Subject: Finding of No Significant Impact (FONSI) for Ulumalu-Peahi
Water System Improvements
TMK: 2-8-01:61 and 64, Haiku, Maui, Hawaii

FINAL ENVIRONMENTAL ASSESSMENT

ULUMALU-PEAHI WATER SYSTEM IMPROVEMENTS
Ulumalu, Peahi, Maui, Hawaii

X. COMMENTS RECEIVED DURING PUBLIC COMMENT PERIOD AND APPLICABLE RESPONSES:

ULUMALU - PEAAHI WATER SYSTEM
 ULUMALU, PEAAHI, MAKAWAO, MAUI, HAWAII
 PLAN & PROFILE - LINE OF SIGHT
 TITLE UPPER ULUMALU RD. TO 300K TANK

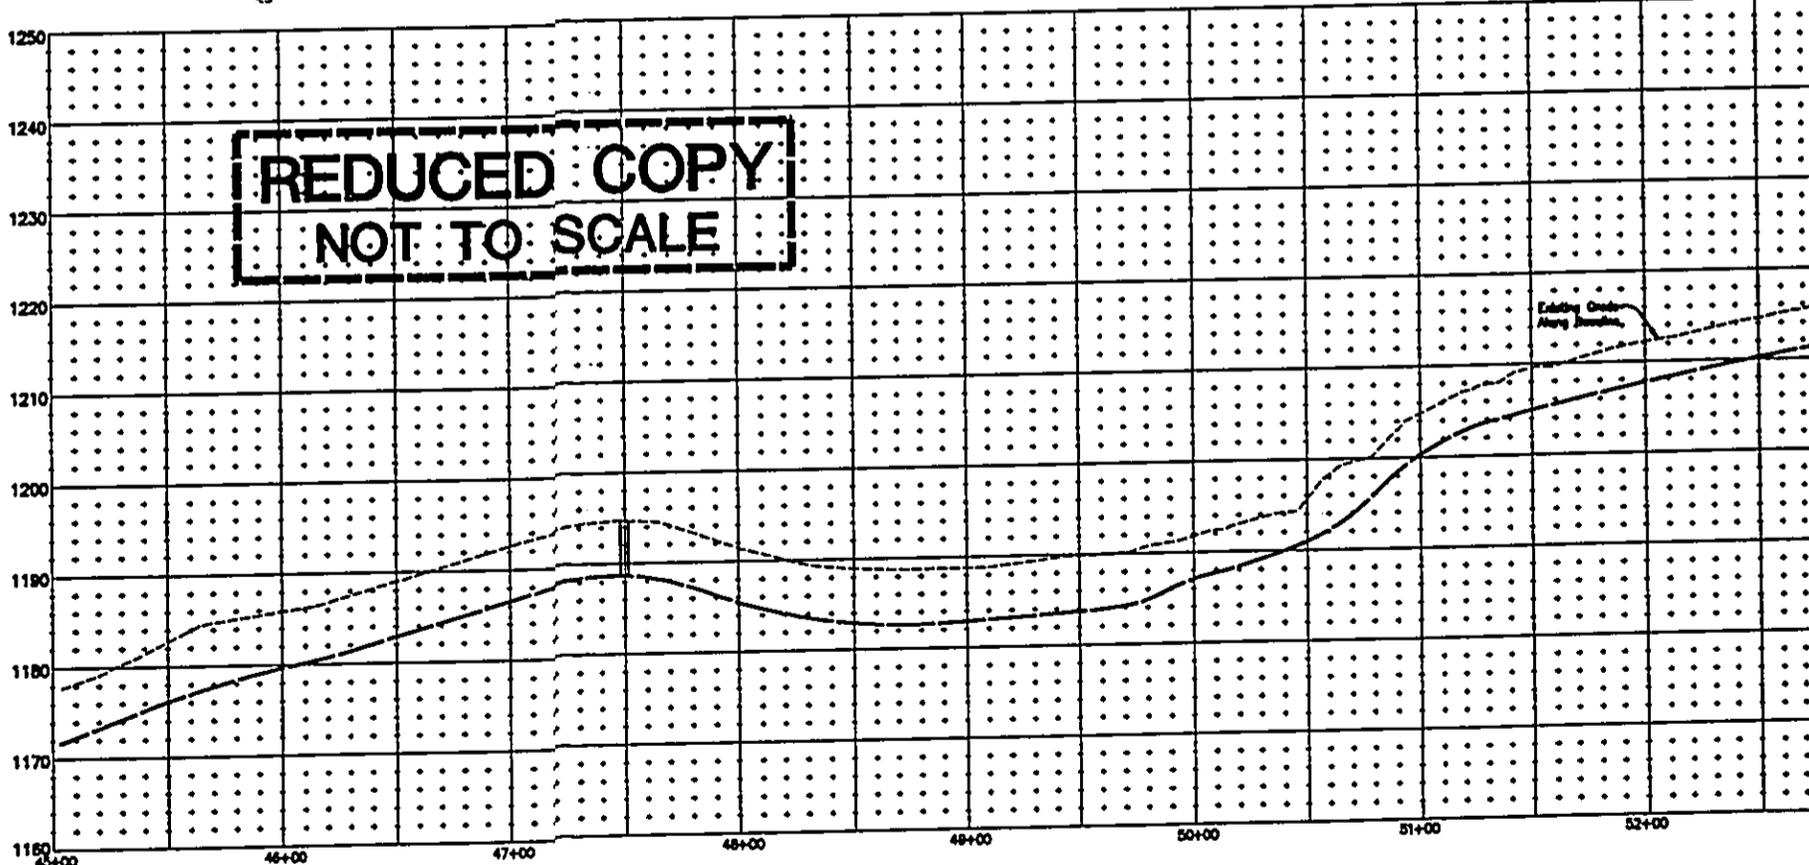
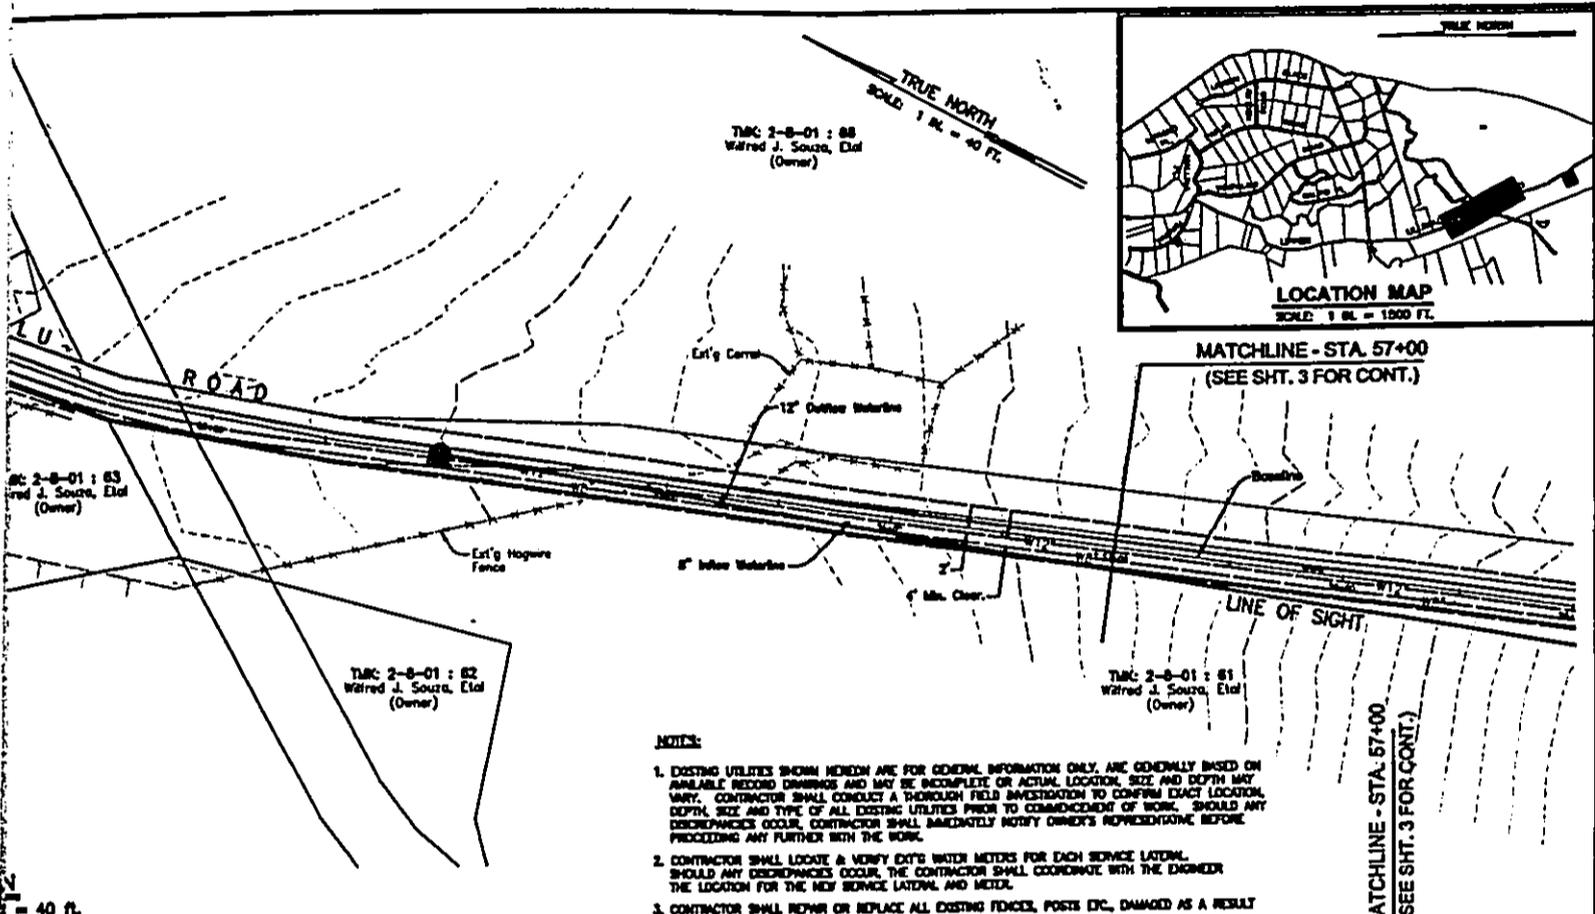
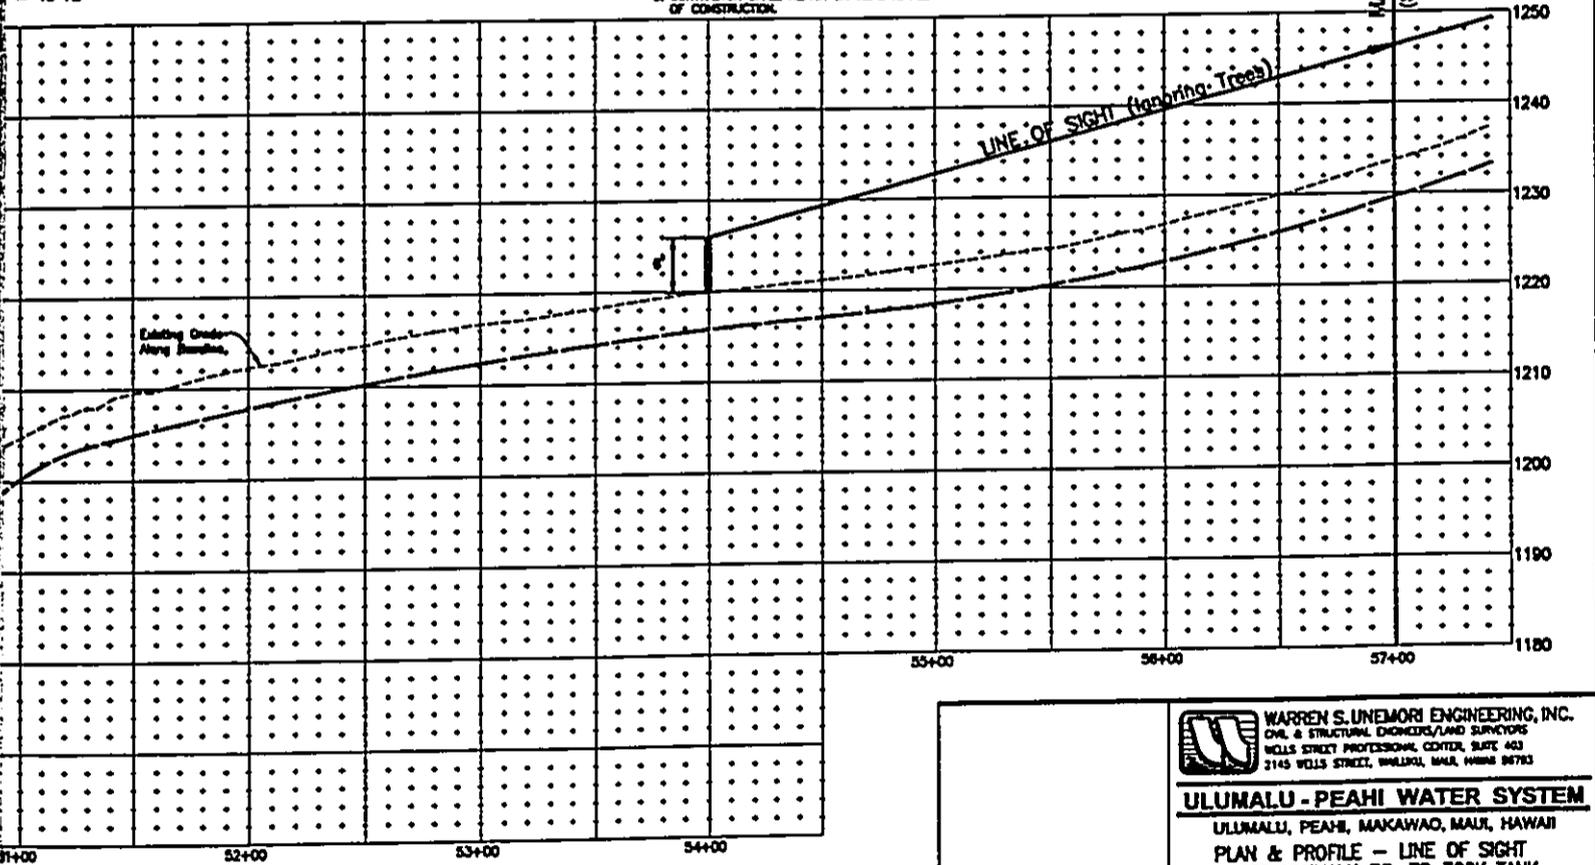
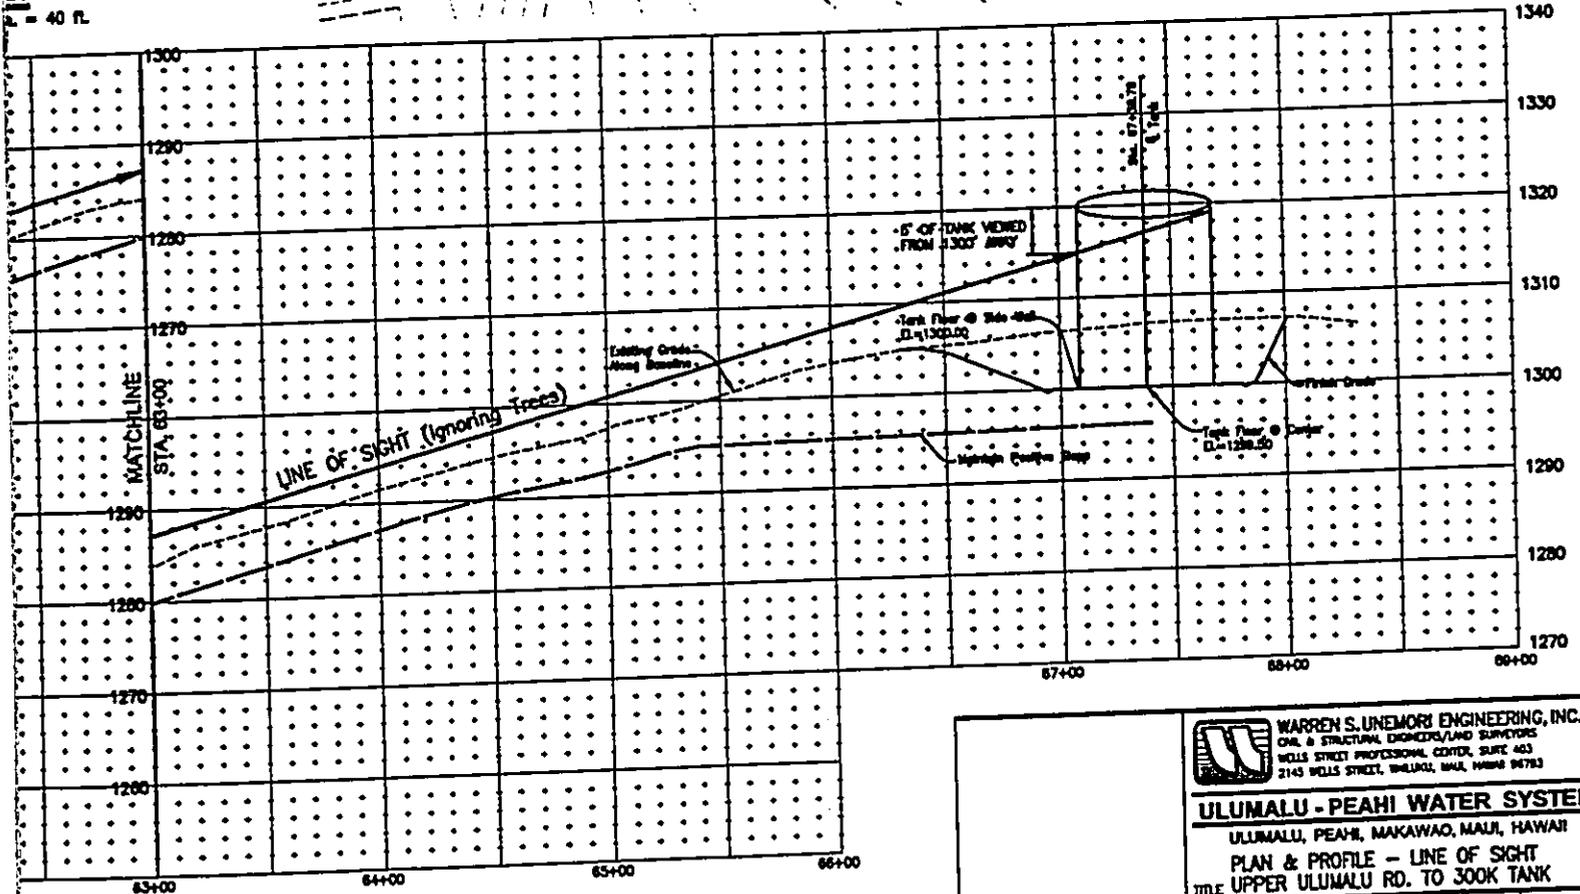
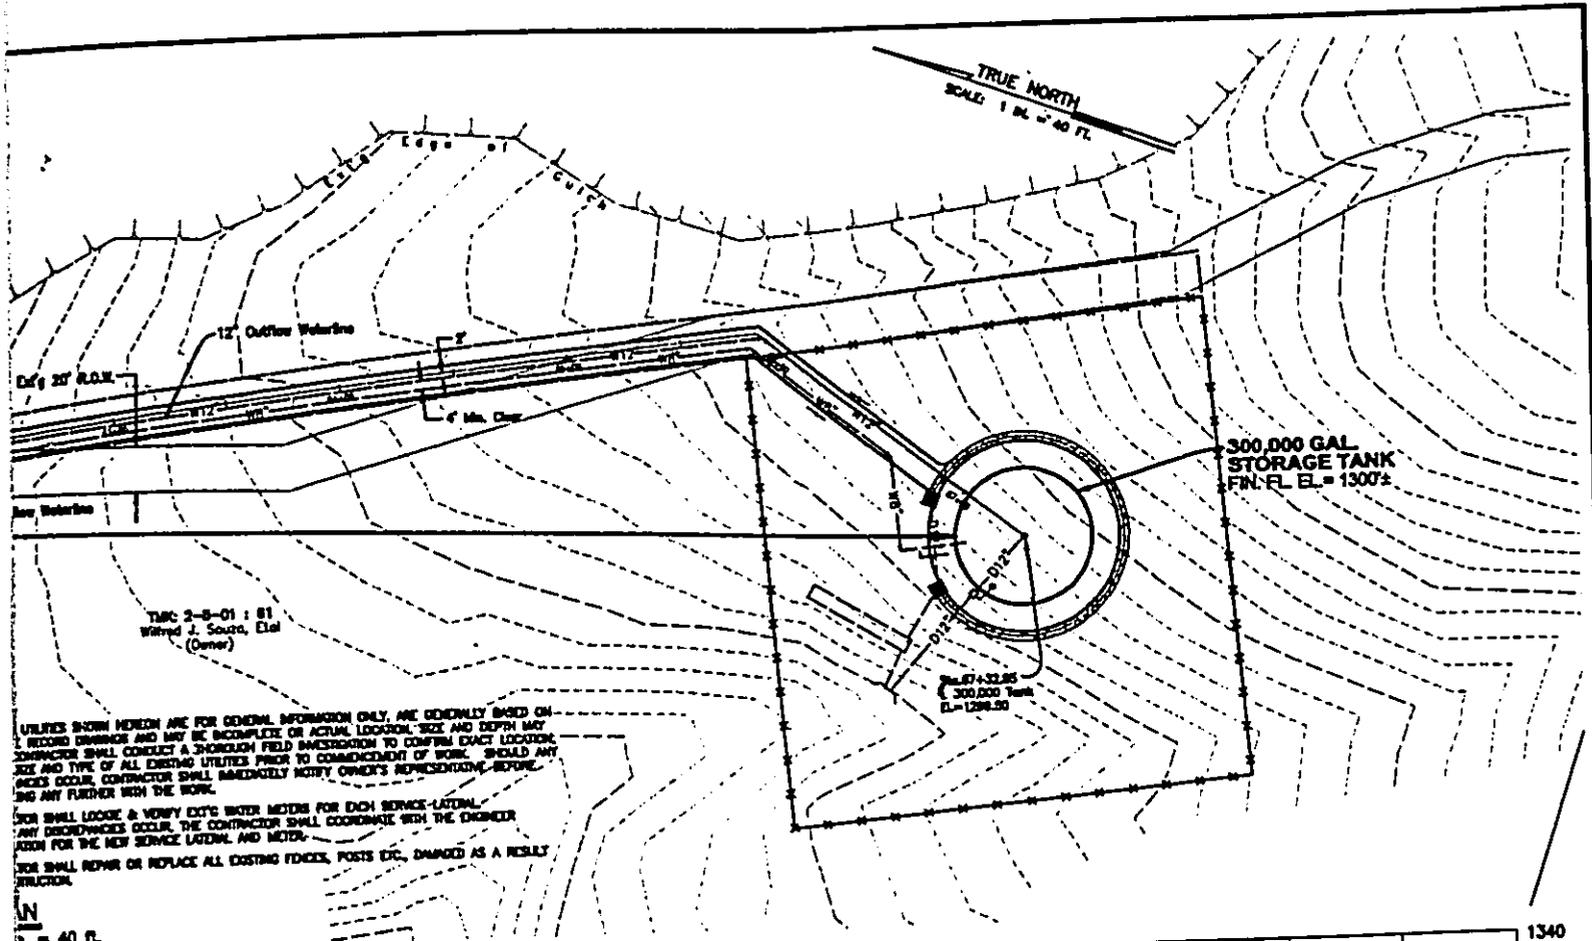
2. What are the height and width of the 300,000 gallon reservoir? Please illustrate the visual impacts of the proposed reservoir from public places such as roads and lookouts. Renderings of future structures superimposed on photos of existing views should be provided. We recommend constructing and painting the reservoir with materials and colors that blend with the surroundings. We also recommend landscaping with native Hawaiian plants to reduce the visual impacts.

- "2. *What are the height and width of the 300,000 gallon reservoir? Please illustrate the visual impacts of the proposed reservoir from public places such as roads and lookouts. Rendering of future structure superimposed on photos of existing views should be provided. We recommend constructing and painting the reservoir with materials and colors that blend with the surroundings. We also recommend landscaping with native Hawaiian plants to reduce the visual impacts.*"

Sheet 1 displays the existing terrain, including contours and vertical sections in elevation, between a point (designated as Section 1) just downhill from the existing corral (at station 54+00), up to the location of the proposed replacement tank. The tank itself is another 1300 feet uphill from this point. On this sheet, we have defined 5 sections, starting at Section 1, at 300 foot intervals, going uphill towards the tank. In the lower left corner of Sheet 1, we have superimposed the existing ground at each of these cross-sections. Note that approximately in the vicinity of Section 3, there is an existing forest of trees which will completely obstruct any view of the tank from a person standing either at Sections 1 or 2. (The existence of the forest of trees is confirmed in Photos 5 and 6 shown in Exhibit "C", and the corresponding locations from which Photos 5 and 6 were taken, as shown in Exhibit "B" in the Draft EA Report)

Sheet 2 and 3 together show in both plan and profile what a 6-ft tall person standing at Section 1 would see even if the trees were removed completely. Namely, all he would be able to see is the top 5 feet of the tank from a distance of 1300 feet (or a quarter of a mile). To put that in more perceptible terms, the tank will look like a quarter laying on the ground from 19 feet away (if you were looking for it!).
